MILITARY SPECIFICATION

MODULES, STANDARD ELECTRONIC

LATCH, DIGITAL, KEY CODE GBL

This amendment forms a part of Military Specification MIL-M-28787/44B(EC), dated 4 August 1982, and is approved for use by the Naval Electronic Systems Command, Department of the Navy, and is available for use by all Departments and Agencies of the Department of Defense.

FIGURE 3. Operating temperature and life test circuit.

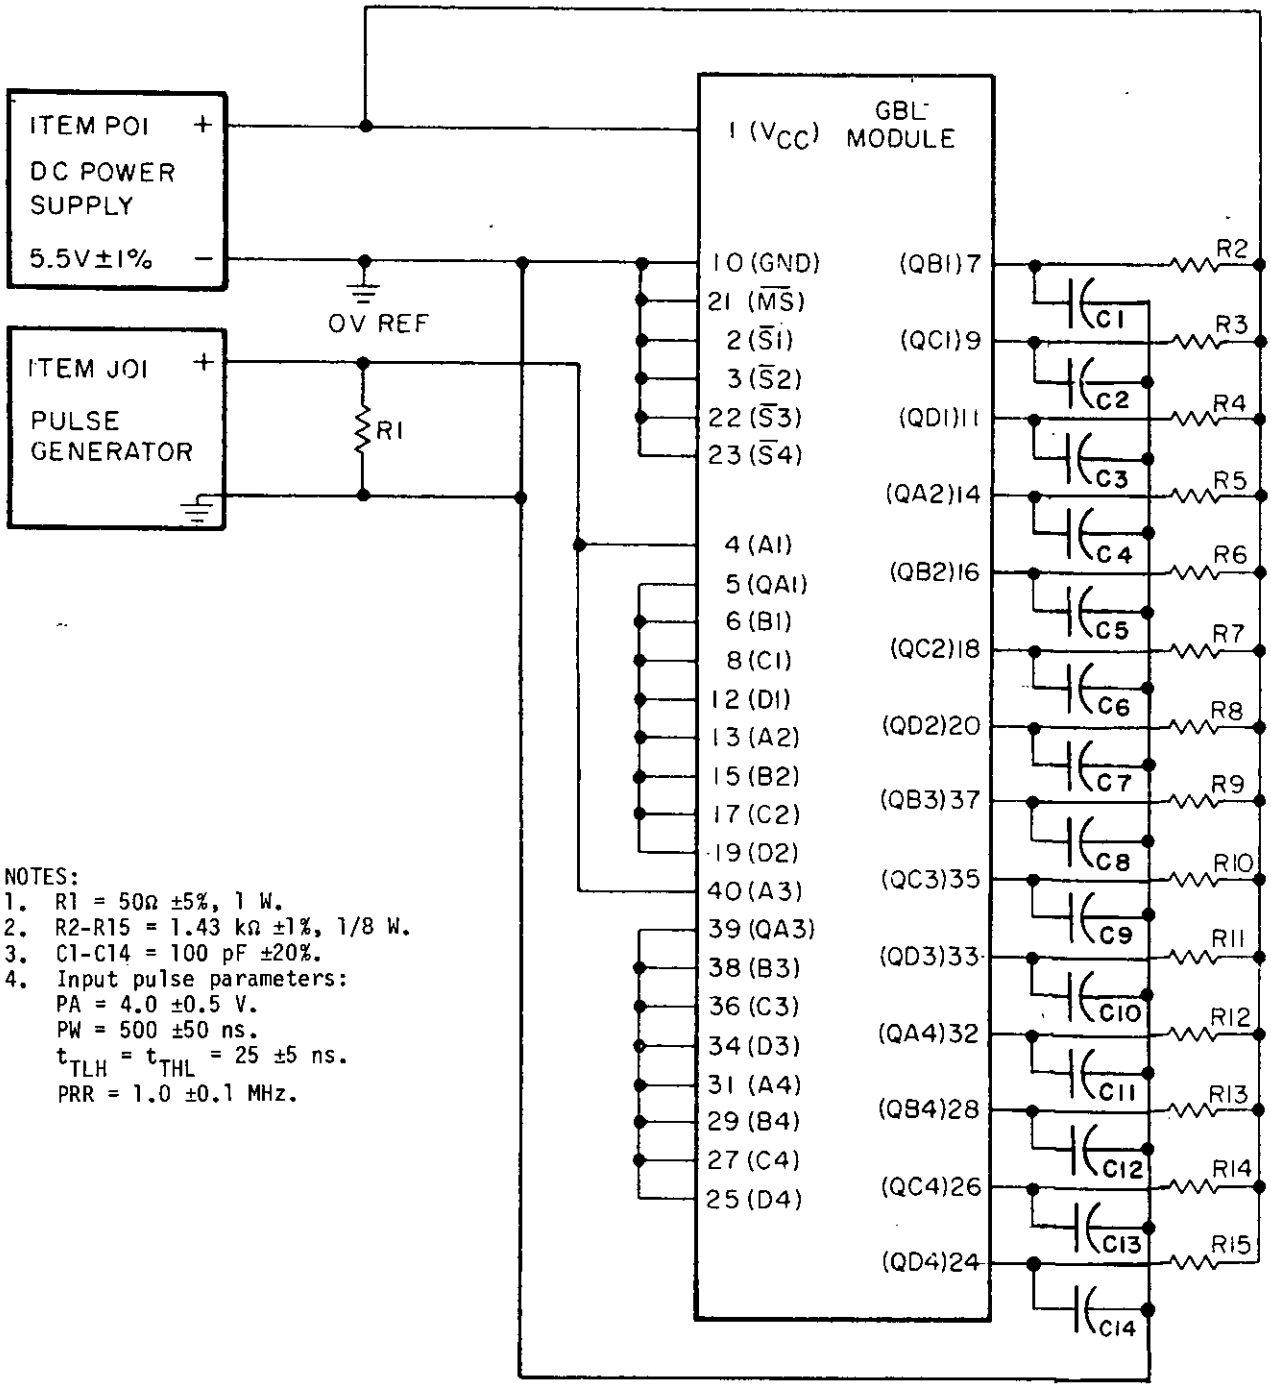
FIGURE 3: Delete and substitute new figure 3 as printed on page 2 of this amendment.
